Mobile Intel[®] Pentium[®] II Processor Specification Update

Release Date: January 2002

Order Number: 243887-036

Old Mobile Pentium® II Processor in Mini-Cartridge Package Label with Supplier Matrix Mark

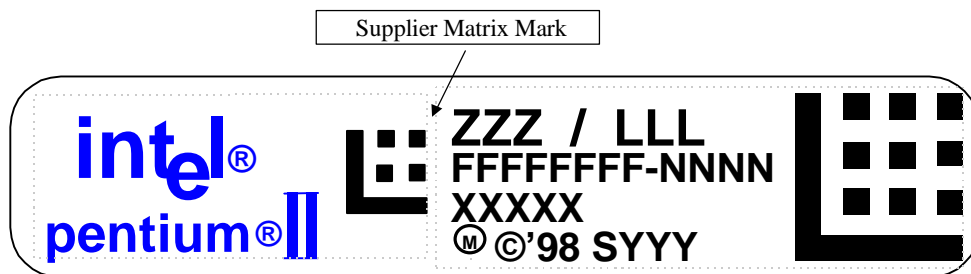
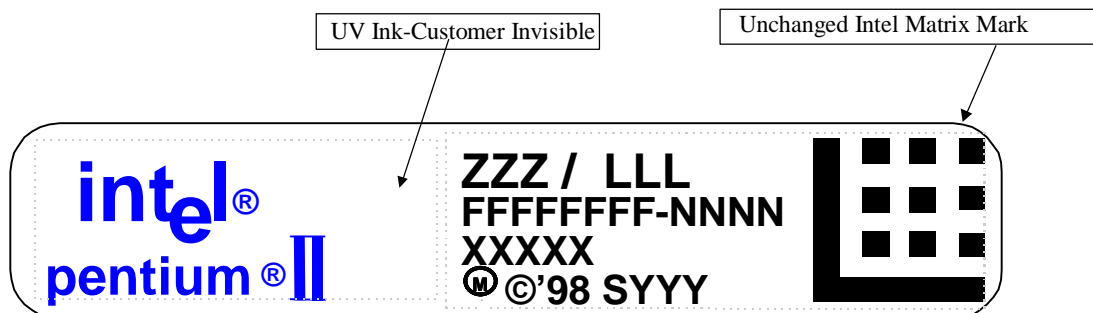
New Mobile Pentium® II Processor in Mini-Cartridge Package Label with Supplier Matrix Mark Removed

Figure 2. Workaround Flowchart: SMBALERT#-Driven System

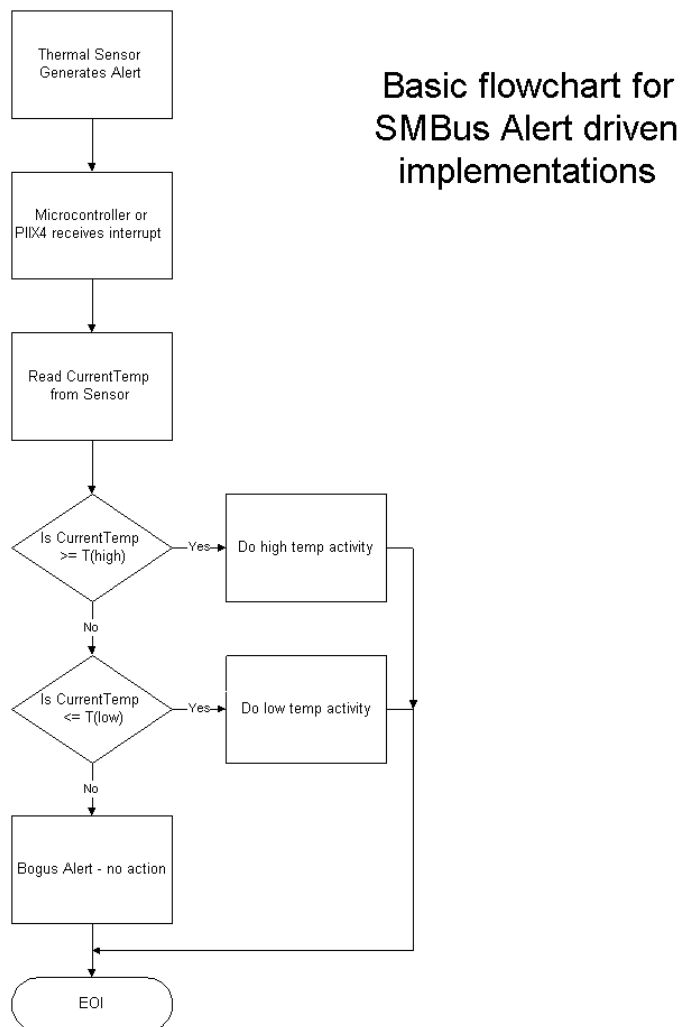
Under the conditions described below, the thermal sensor incorrectly generates the SMBALERT# interrupt. All of the following conditions must be met to trigger a false interrupt:

1. Before servicing an interrupt from the thermal sensor, read and compare the processor thermal reading with the threshold limits (T_{HIGH} or T_{LOW}). Figures 2 and 3 provide basic flowcharts for the implementation of this workaround in an interrupt driven system.
2. If the firmware implemented polls the Status Register only, then before taking any action, re-read the temperature register and do a comparison with the alarm threshold limits (T_{HIGH} or T_{LOW}) to determine if the value is actually still within the temperature window.

3. Use a temperature polling scheme to monitor the processor temperature.

Figure 1. TAP Gageable Thread Clarification

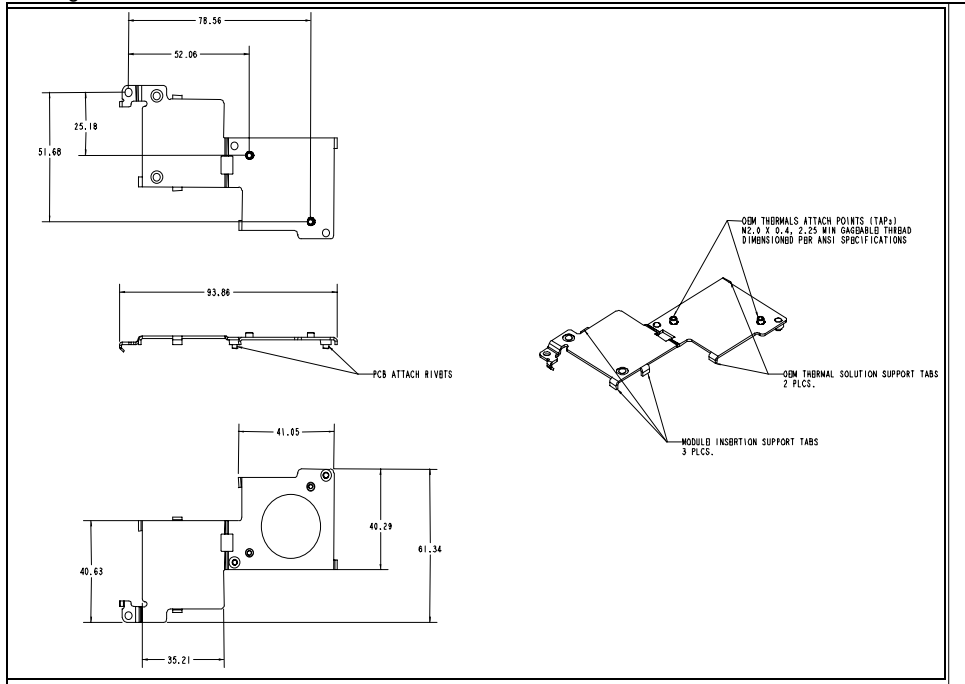
In the *Intel® Pentium® II Processor Mobile Module : Mobile Module Connector 1 (MMC-1)* and the *Intel® Pentium® II Processor Mobile Module : Mobile Module Connector 2 (MMC-2)* datasheets (Order Numbers 243667 and 243668, respectively), the thermal attach point (TAP) gageable thread specification was not clearly identified in Figure 14, of Section 5.2. The following is the TAP clarification:

OEM Thermal Attach Points (TAPs) M2.0 x 0.4, 2.25 min gageable thread dimensioned per ANSI specification.

See Figure 1 below for more information.
